Interim Reclamation Inspection

Operator: KERR MCGEE OIL & GAS ONSHORE LP- #47120

Location ID: 441199

Location Name: WILSON RANCH /5C-27HZ

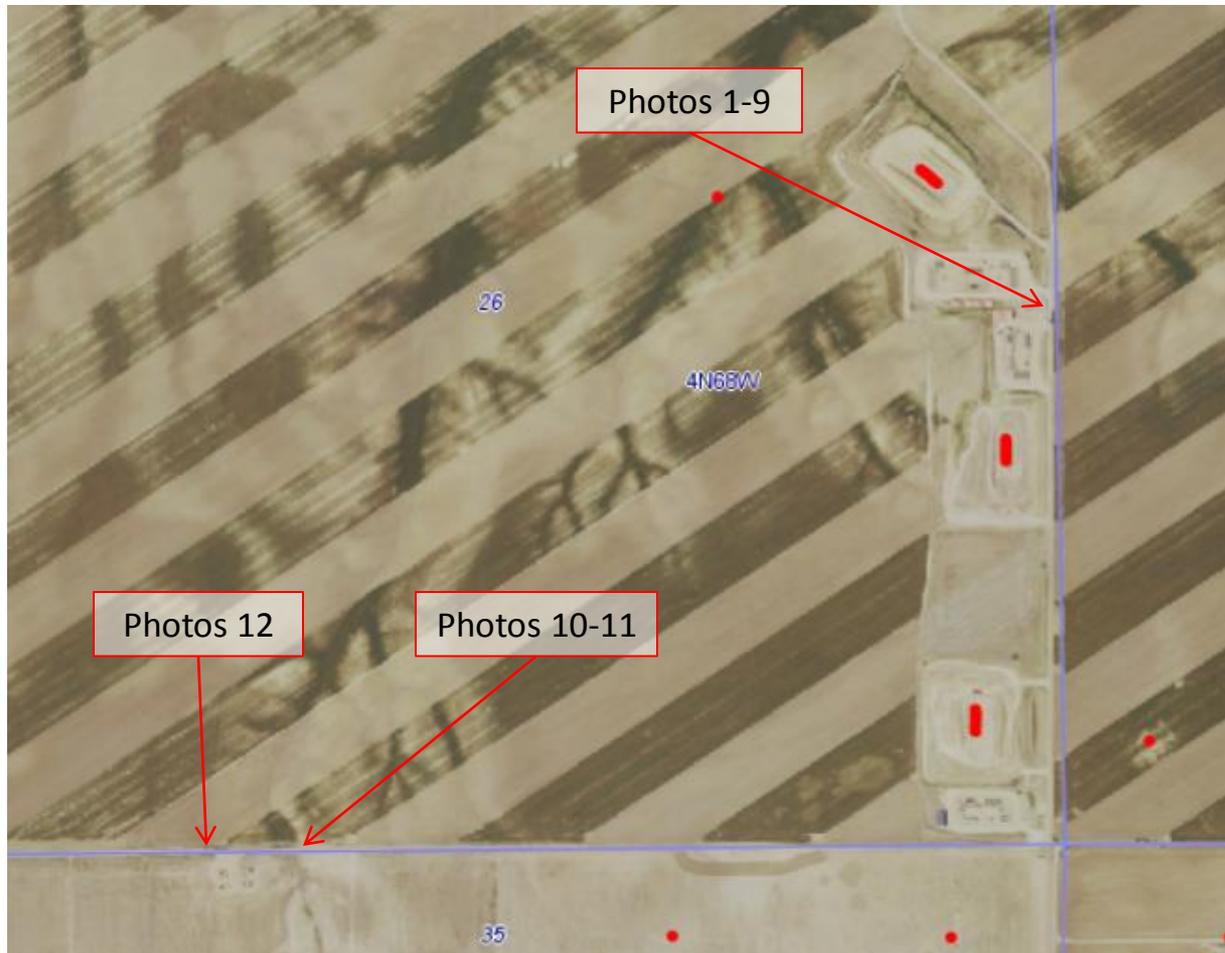
Aerial imagery to help illustrate the approximate photo locations during this inspection.
